# UNITED STATES PATENT AND TRADEMARK OFFICE

APPLICATION NO.	FILING DATE	FIRST NAMED INVENTOR	ATTORNEY DOCKET NO.	CONFIRMATION NO.
10/720,138	11/25/2003	Mei-Ling Liu	LIUM3007/EM	4425

**Office Action Summary**

### **DETAILED ACTION**

FIG. 7  
PRIOR ART

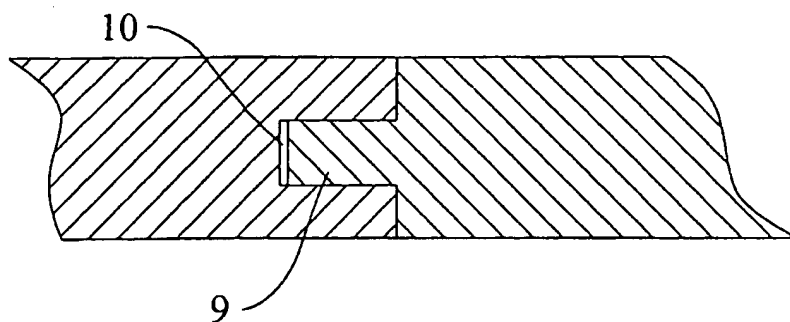
The drawings are objected to under 37 CFR 1.83(a). The drawings must show every feature of the invention specified in the claims. Therefore, the "longitudinal notch having a upper side and a long lower side" must be shown or the feature(s) canceled from the claim(s). No new matter should be entered.

Corrected drawing sheets in compliance with 37 CFR 1.121(d) are required in reply to the Office action to avoid abandonment of the application. Any amended replacement drawing sheet should include all of the figures appearing on the immediate prior version of the sheet, even if only one figure is being amended. The figure or figure number of an amended drawing should not be labeled as "amended." If a drawing figure is to be canceled, the appropriate figure must be removed from the replacement sheet, and where necessary, the remaining figures must be renumbered and appropriate changes made to the brief description of the several views of the drawings for consistency. Additional replacement sheets may be necessary to show the renumbering of the remaining figures. Each drawing sheet submitted after the filing date of an application must be labeled in the top margin as either "Replacement Sheet" or "New Sheet" pursuant to 37 CFR 1.121(d). If the changes are not accepted by the examiner,
